Memorandum

From: Meredith Jones, P.E. V.P., Eden & Associates

RE: Variances/Exceptions for Glade Spring Rezoning Application

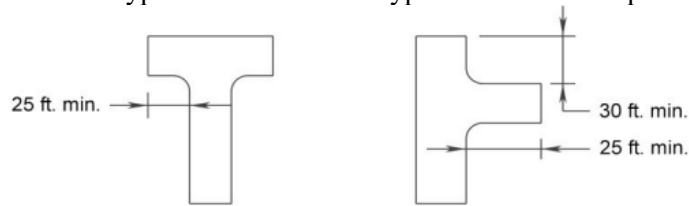
- a. Applicant requests express approval through rezoning for no curb and gutter in the North Area (portions of Street A and all of Street E) where ditch section will be used for conveyance and infiltration of stormwater.

- b. Reason: In order to maintain affordable housing in the development, only critical infrastructure can be included. Curb and gutter along these areas, with an estimated cost of approximately \$160,000, is unneeded from an engineering standpoint to convey water safely and effectively. While it is a luxury many homeowners expect because they don't want to see water traversing their lot, it is not always required from an engineering standpoint. The underlying zoning RR-1 does not require curb and gutter for more rural area uses. This is because larger lots do not necessarily need it for proper engineering conveyance of stormwater. It is a sustainable benefit to the development to allow stormwater to flow over lawns as opposed to immediately capturing it in a curb/gutter and storm drain. The proposed development on Streets A (North side) and E is similar in density and character as the existing adjacent development on Village Way South, which does not utilize curb and gutter. Street drainage running perpendicular to lots can be diverted across lots as overland flow or diverted between lots in gradual swales, encouraging some infiltration. Flow running parallel to the fronts of lots can be contained in ditch sections with 15" culverts under driveways where needed. Storm inlets can be provided to divert flow across the street where needed for engineering. Elimination of curb/gutter will also allow for guest parking in a reinforced grass shoulder off the side of the road, allowing for more room to pass vehicles in the street.

FIGURE B(1)-12 CULS-DE-SAC AND TURNAROUND DETAILS

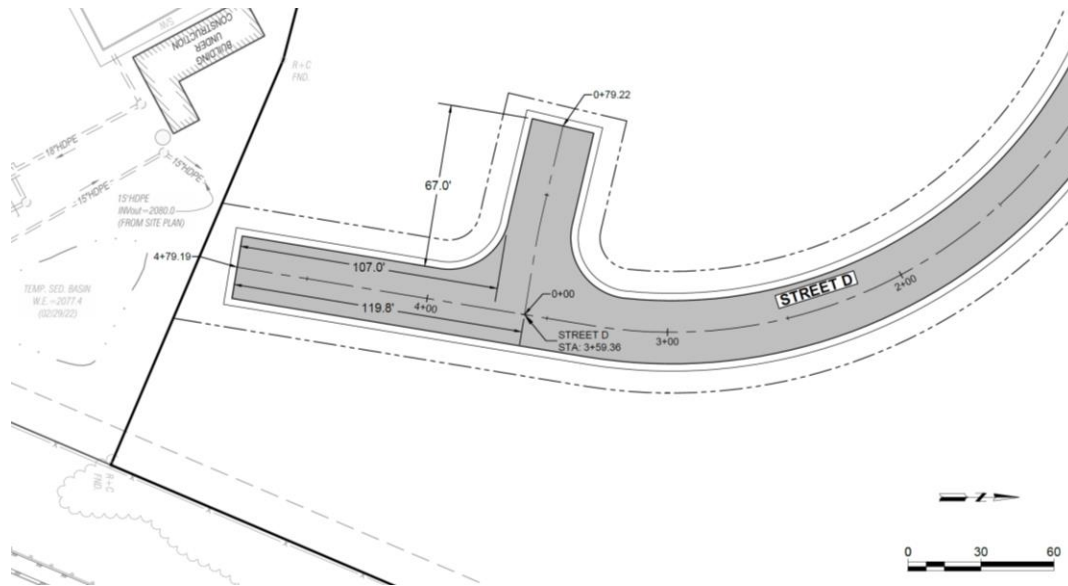
6. **Variance for Cul-de-sac (Sec. 5-310).** Sec. 5310 – Cul-de-sacs states that the agent or Planning Commission may permit a “T” or a “Y” cul-de-sac. VDOT Appendix B(1) Section 4G addresses the permissible cul-de-sac and turnaround designs for new subdivision streets. This section of Appendix B(1) specifically describes the permissible types of “alternative turnarounds” permitted. The two alternatives are the “T-type” and the “branch type” turnarounds depicted below.

The engineer aims to apply the minimum dimensions described in Sec. 5-310(b) to the “branch type” turnaround to meet the requirements of Sec. 5-310(a). The engineer notes that the Town of Blacksburg Subdivision Ordinance does not specify a maximum length of the turnaround legs. Appendix B(1) Section 4G(d) states the following regarding stub streets: “A turnaround should be provided for any temporary or stub street longer than 150’ from the point of intersection to the end of pavement.” As such, the maximum length of any leg of a T or branch type turnaround is 150’ from the point of intersection. As shown in the exhibit below, the proposed turnaround meets the minimum requirements of Sec. 5-310(b) and Figure B(1)-12, while not exceeding the maximum stub length of Section 4G(d). Furthermore, by exceeding the minimum leg lengths, the branch facilitates turnaround movements by the design vehicle, the single unit truck (e.g., a garbage/recycling pickup truck), or larger vehicles such as a school bus.

Beyond the design requirements for a branch turnaround, the design is needed in this location to maintain development density, and thus affordability, in the development. The existing trail constructed as part of “The Farm at Blacksburg” development terminates at the shared property line near this location. Given the configuration of “The Farm” site and the existing topography, minimal modification to the existing trail can occur while extending the trail into the proposed Glade Spring Crossing development. All proposed trails in the Town of Blacksburg have a maximum slope of 8% while streets have a maximum slope of 10%. These two maximum slopes restrict the ability of the engineer to either: a) raise the proposed features to meet the trail or b) rapidly descend from the existing trail into the development. The proposed branch turnaround enables Street D to: a) extend to the maximum possible elevation thus flattening the trail entering the site and b) maximize grading flexibility and buildable areas. Other turnaround designs, such as the T or bulb would required a shorter length of street to be constructed and thus less available frontage for proposed dwelling units. *A minimum of 2 or 3 units would be lost by utilizing a traditional bulb. In design of that scenario its likely the trail would have to be located to the east of Street D causing the lots to incur more fill and units to be pushed closer to 460 limited access right-of-way. This would be more costly and create less desirable lots.*

#10 Additional Exhibit

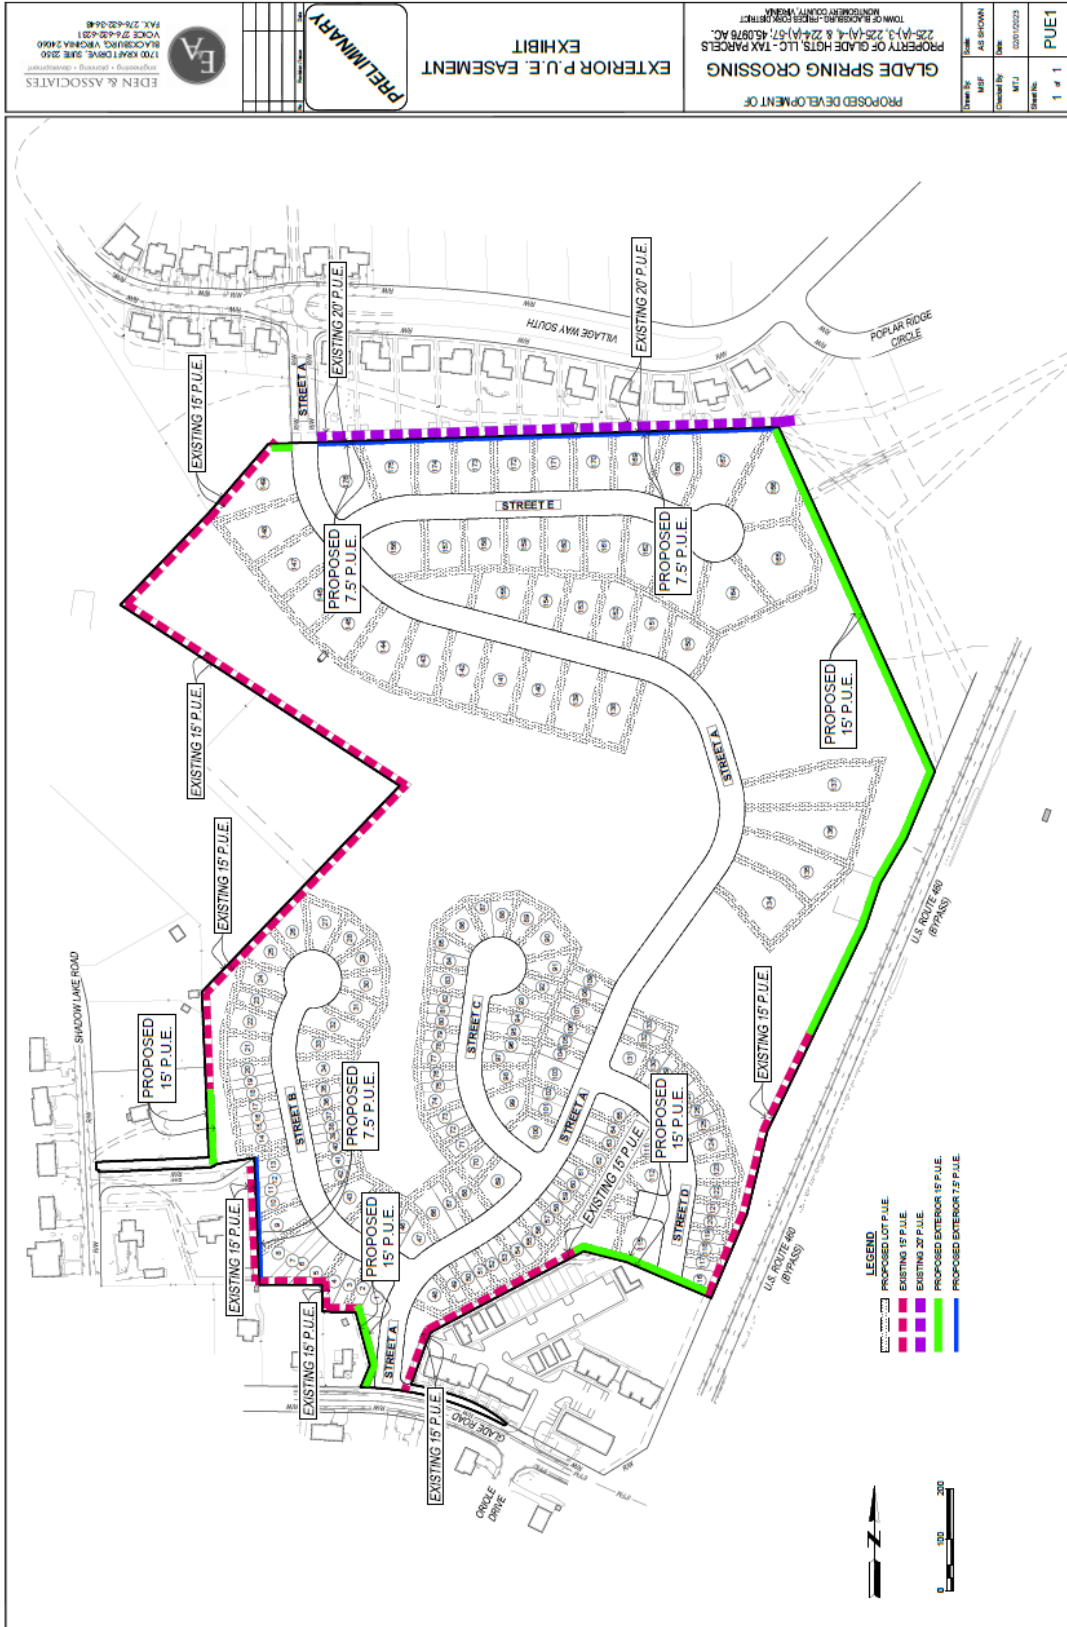
- a. Applicant Request to reduce the minimum easement width interior to some perimeter lot lines to 7.5 feet where easements already exist on the exterior perimeter. *(removed the request for front property line)*

- b. Reason: Easements already exist along some perimeter lot lines interior and exterior to the property. Where easements do not currently exist on either side of the perimeter, the applicant will dedicate 15'. However, where easements already exist on the outside of the perimeter, applicant requests 7.5' interior. The resulting easement for the P.U.E's on the perimeter would be a total minimum of 15' and in some cases 22.5' or 27.5'. *The density of the lots required does create lots that are limited in length from front to back. Setbacks on the south area are 10' so a 15' interior lot line P.U.E. on some of these lots would necessitate pushing the units forward. This has an impact on road location, fill required, and potentially could make lots unable to conform, thus losing some lots as a result. Again, this is only proposed in locations where an existing 15' easement already exists and a total of 22.5' wide P.U.E. will result and should be more than adequate for utilities. A minimum of 15' will be provided interior to exterior lot lines where no easements already exist on the other side. See the exhibit below.*

#11 and #13 Exhibits: Driveways in front of building line (Townhouses and Two-family dwellings): no more than two consecutive driveways of 18'

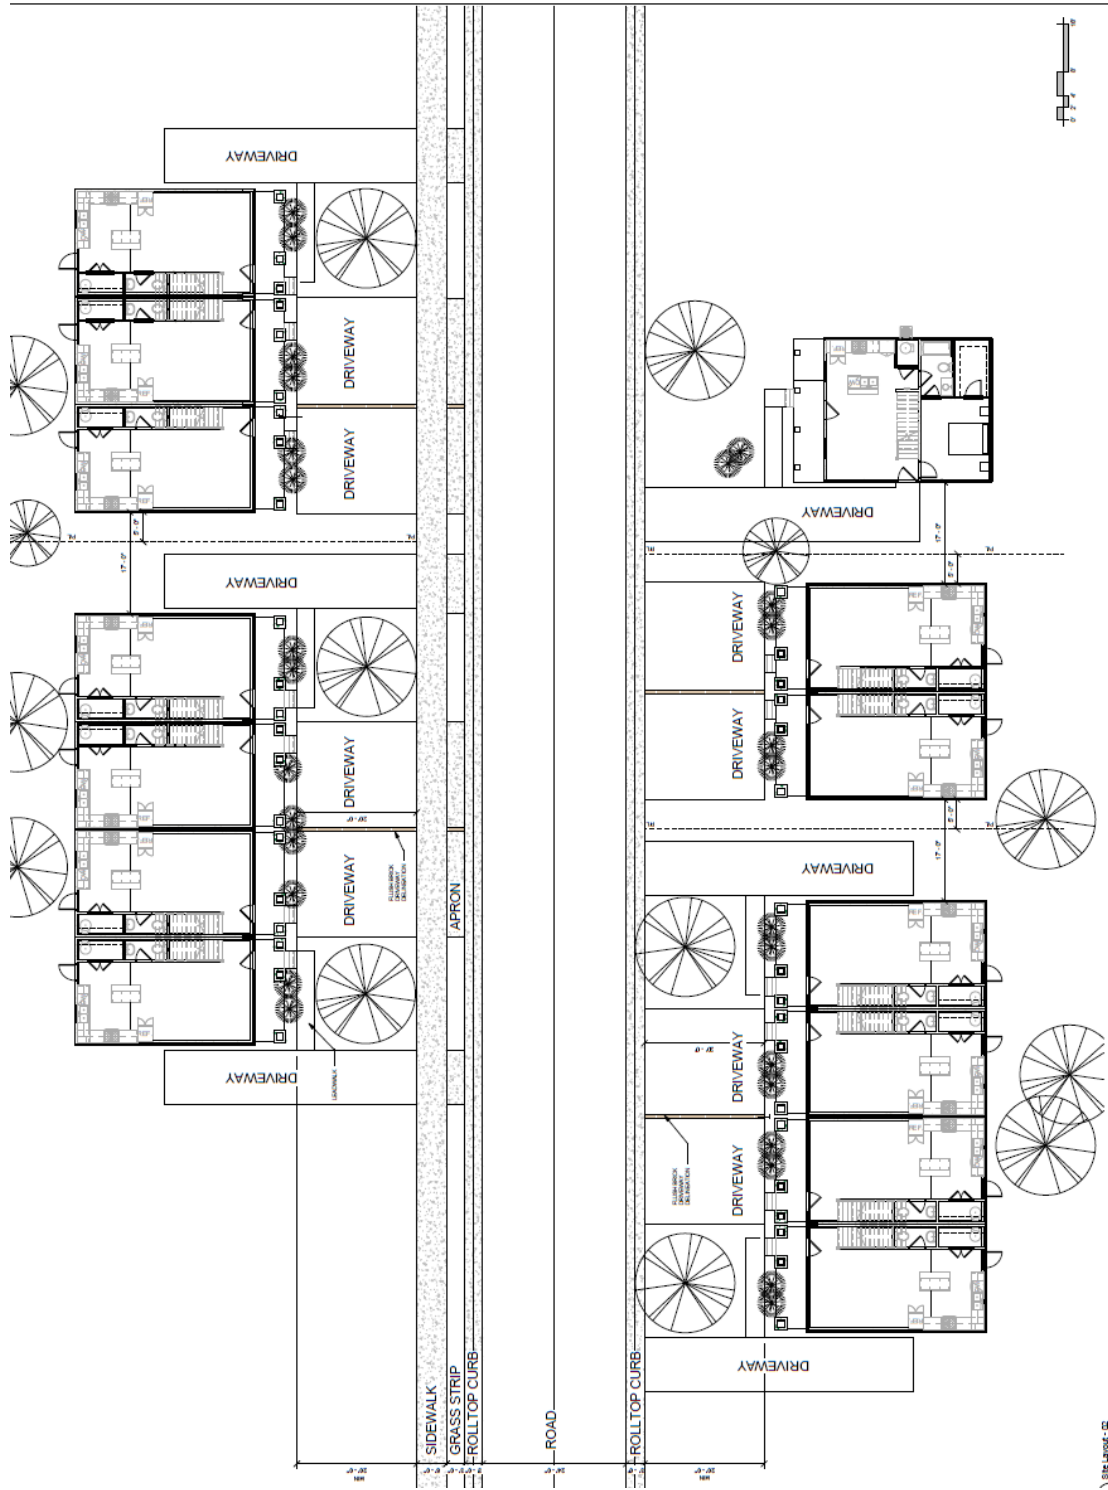
11. **Special exception to 4231(b)(6)** requires all parking for townhomes to be located behind the front building line.
 - a. Applicant requests parking to be allowed in front of the building line.

- b. Reason: These townhomes will function as fee simple lots with street frontage on public roads rather than use of parking lots on a common parcel. Therefore it is important that all units, but especially middle units that have attached side walls, be permitted parking in the front. The shape of the lots, given steep topography and the density needed, will not allow for drive-aisles to the rear or side, and space for parking in these areas. While some townhome lots will allow for side parking, there will still be parking in front of the building line in that driveway. The desire is for these townhomes to function as single-family homes with their own driveways. This is important for seamlessness in equity between affordable, workforce, and market rate units must exist. Furthermore, parking in the rear would simply add more impervious area increasing stormwater concerns, decrease open space, and reduce the density of the development which is critical to the success of the development.

- c. Additional concessions: To allow some break in the front yard pavement, the applicant has created additional site development regulations that minimize the number of contiguous 18' wide driveways to two. This provides for breaks in driveway entrances and increases green space in front of the townhouse units for landscaping. An exhibit is included to demonstrate the results.

13. **Special Exception to 4241 (a)(2)** requiring parking for all two-family dwellings to be located behind the front building line.
 - a. Applicant requests parking to be allowed in front of the building line.

- b. Reason: The two-family dwellings will function as fee simple lots with street frontage on public roads rather than use of parking lots on a common parcel. Therefore it is important that all units, be permitted to have parking in the front. The shape of the lots, given steep topography and the density needed, will not allow for drive-aisles to the rear or side, and space for parking in these areas. While some two-family dwelling lots may accommodate side parking, there will still be parking in front of the building line in that driveway. The desire is for these to function similar to single-family homes with their own driveways. This is important for seamlessness in equity between affordable, workforce, and market rate units must exist. Furthermore, parking in the rear would simply add more impervious area increasing stormwater concerns, decrease open space, and reduce the density of the development which is critical to the success of the development.

#14 Backing out of Townhouses: Exhibit looking at drive aisles and individual driveway configuration (from #11)

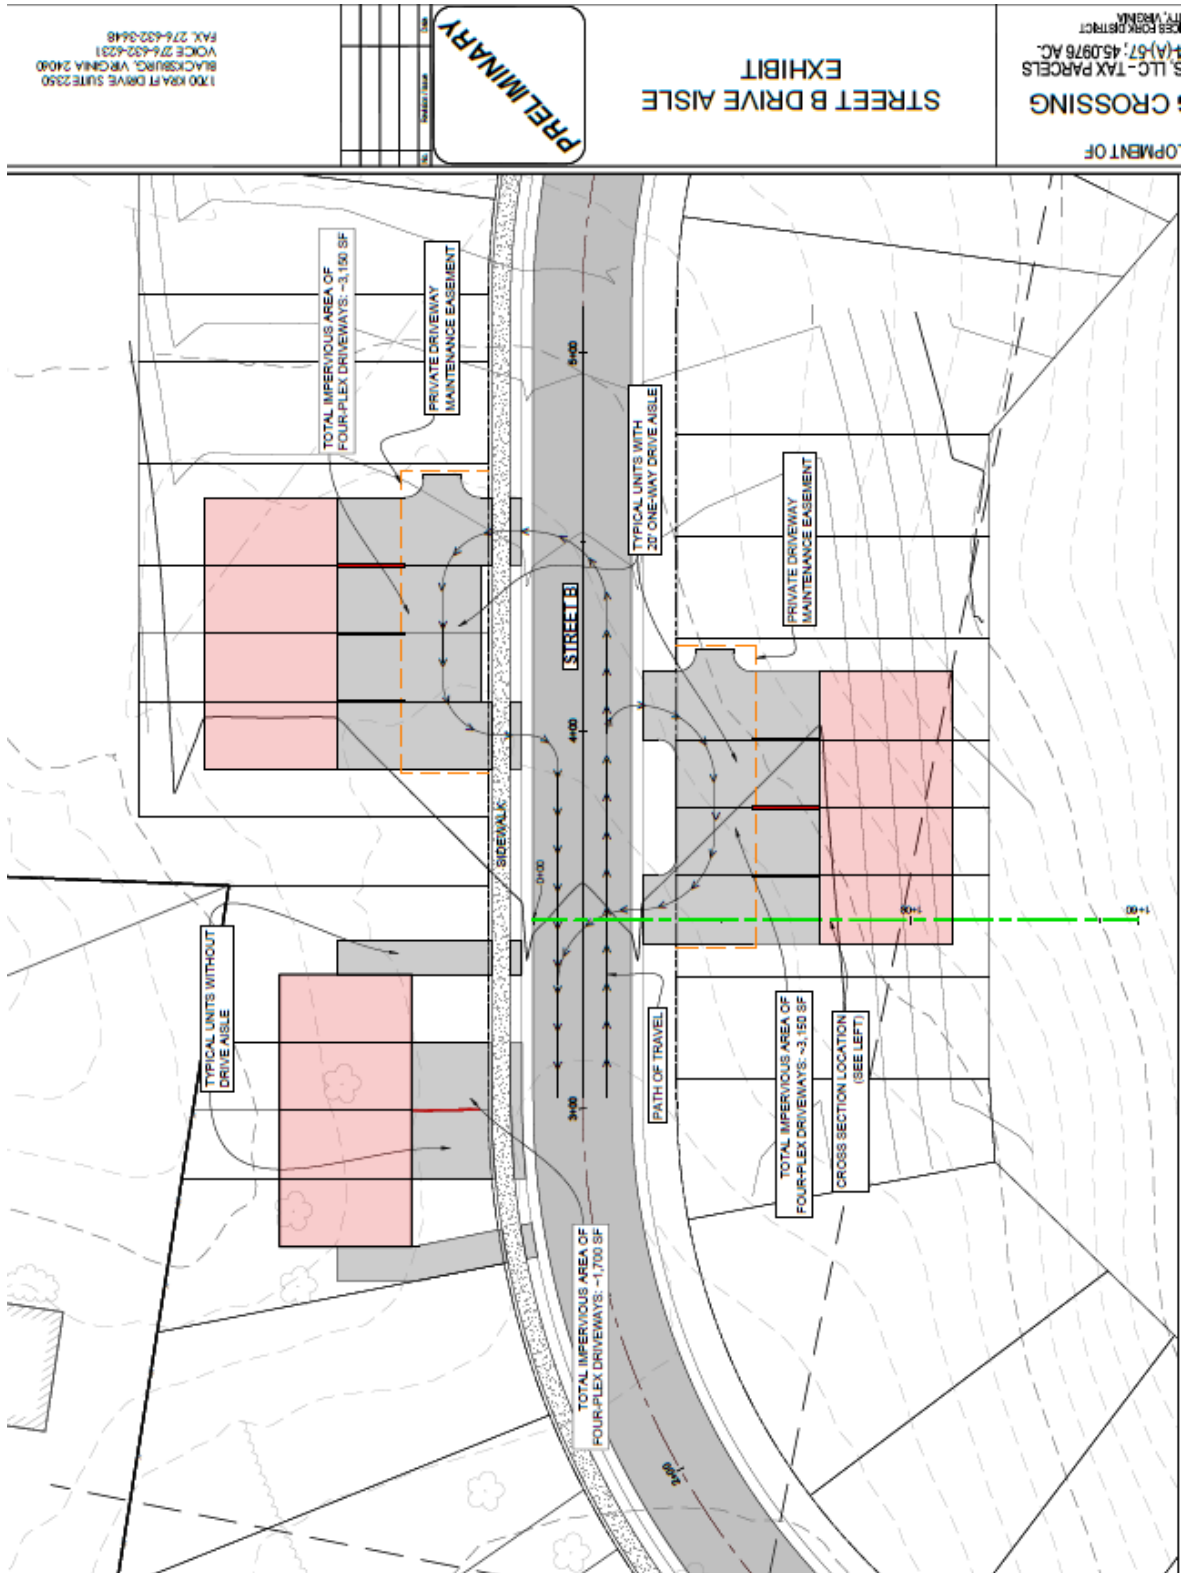
14. **Special Exception to 5202 (c)** all parking spaces shall be located such that maneuvering in or backing into a public street shall not be permitted. Single-unit dwellings and two-family dwellings on a local street are exempt, but not townhouses.

- a. Applicant requests that driveways to townhomes that contain parking spaces be permitted to back out into the public street.
 - b. There does not exist room on the site to accommodate “turn-arounds” or separate drive-aisles in order to meet the ordinance requirements. The applicant evaluated examples and those are included in the exhibits below. The result of this analysis shows that additional cut and fill areas are prohibitive with the lot geometries shown on the plan. Furthermore, in comparing the preferred alternative (separation of driveways so that no more than two contiguous driveways exist from #11), with the drive aisle alternative, there is little difference in pedestrian conflict areas. Both provide adequate breaks for the pedestrian and for the view of the driver backing out. Driveway entrances still exist in either scenario; though certainly the driver is facing forward on a drive aisle scenario. The preferred scenario preserves less impervious surface, less cost, and accommodates the current lot configurations better. As is seen on the exhibit, lot depths significantly increase in a drive-aisle scenario and would restrict which lots could accommodate townhomes in an already restrictive elevation setting. A cross section example is shown on the low side of the road, which makes it apparent how much more grading would be needed, adding cost, but also reducing usable backyard space deepening lots, and reducing open space. Furthermore, the goal of the development is to create affordable units and that requires keeping homeowner’s association fees low. A drive aisle would have to be contained in a privately maintained easement, across private lots, whereby the HOA would have to maintain these areas separately from the unit owners. This is not a preferred option for the HOA, and to expect private owners to maintain their portion of the drive aisle is an unrealistic expectation as well as expensive.
